WEST BERKSHIRE COUNCIL

LAND ADJACENT TO 1 GABLES WAY, BATH ROAD, COLTHROP, THATCHAM

REF 21/02130/OUTMAJ

Consultation response dated March 2022

Aerial photo showing different landscape characters of Colthrop Industrial Estate. Area B has a more treed character compared to Area A. Area B collectively also acts as a buffer/screen to the open landscape to the east where the site is located

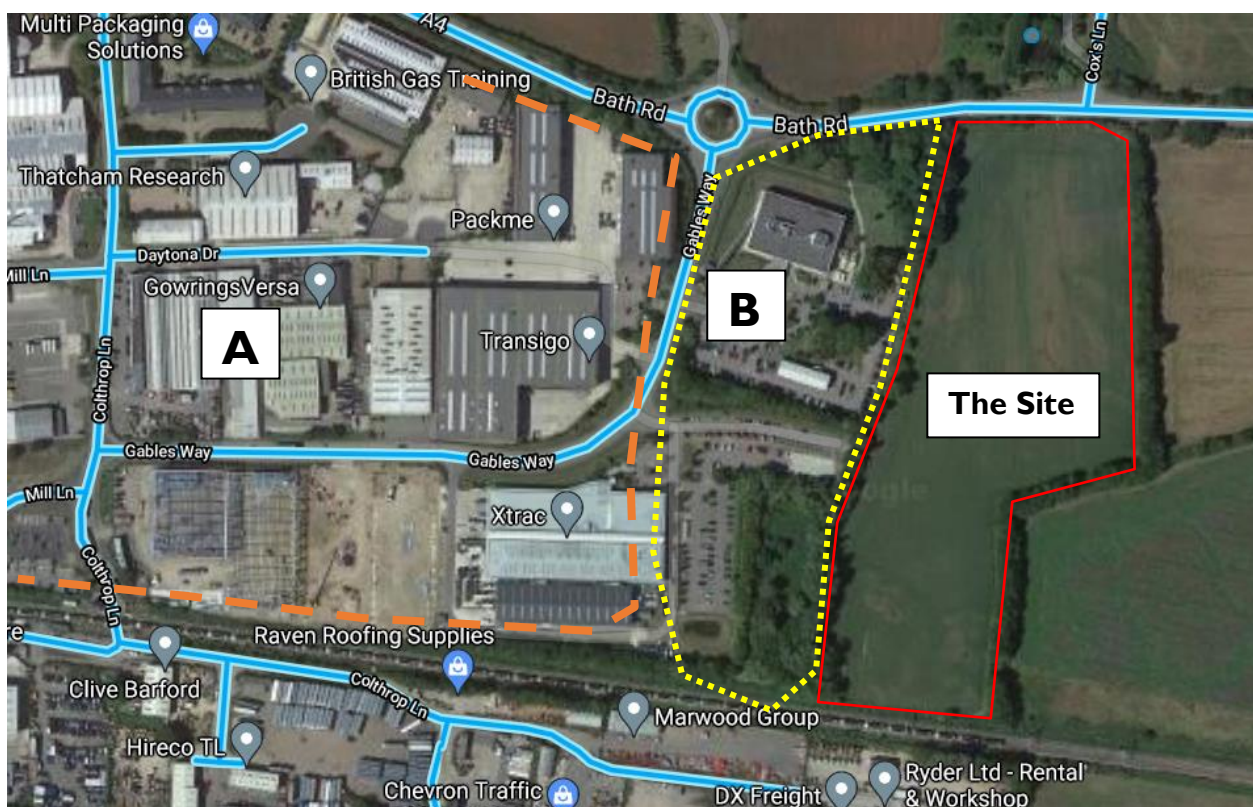
The boundaries of the site, as described within the LVIA state that the eastern boundary was planted about 20 years ago as three rows of trees (measuring across 5m). This eastern boundary is now (at the northern end) a mix of 2-3 intermittent rows reducing down to a single row at the southern end. As viewed on site there is little undergrowth within the eastern tree belt permitting low level views from the east (PRoW) through into the site. The site boundary to the west abuts a more robust tree line, which concludes at the northern end (adjacent the Bath Road) as a small woodland copse, with a number of trees with TPOs. At the southern end, the western site boundary aligns a row of trees, with a balancing pond further beyond to the west, with more trees, before an adjacent car parking area within Colthrop Industrial Estate. As shown within the LVIA's site photos, in particular View B (LVIA page 17), this western treed boundary provides a good screen to Colthrop Industrial Estate from the wider landscape to the east. Additionally, Viewpoint F (LVIA page 19), illustrates a view from within the site north up to the Kennet Valley side, with Colthrop Industrial Estate to the west screened from view.

Photo LA3 – north of Colthrop Manor (May 2021). The site forms part of the wider seemingly undeveloped wooded valley floor of the Kennet valley

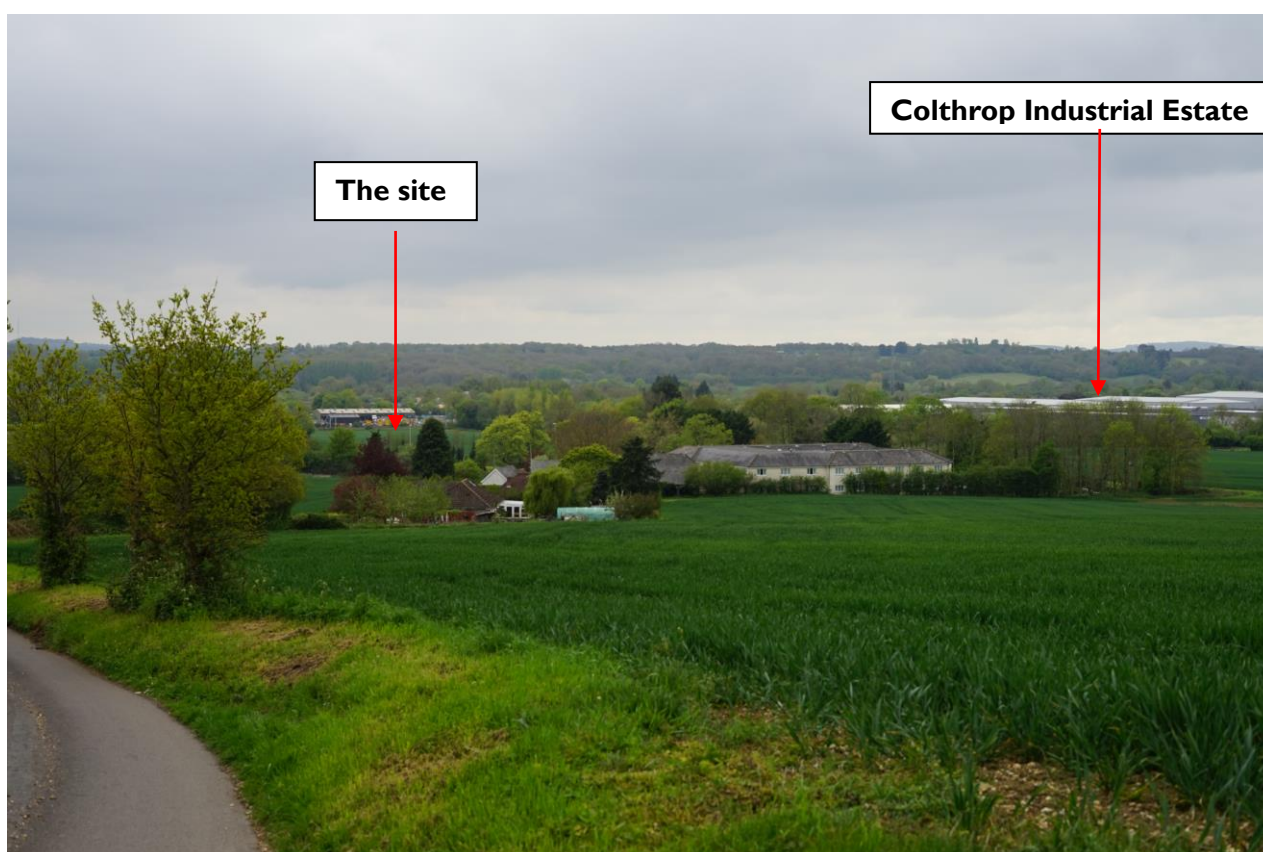
Views from Cox's Lane (to the north of the site) (Viewpoints 7, 8, and 9). As Cox Lane ascends the Kennet Valley side, there are views down across the Kennet Valley floor, viewed as well-wooded. Where there are views of the existing Colthrop Industrial Estate, this area reads as a contrasting area of pale grey-white tones, which contrasts with the adjacent areas of woodland (dark green). The site is also separate from this area of pale tones by the wooded western boundary to the site (see photo on next page LA3).
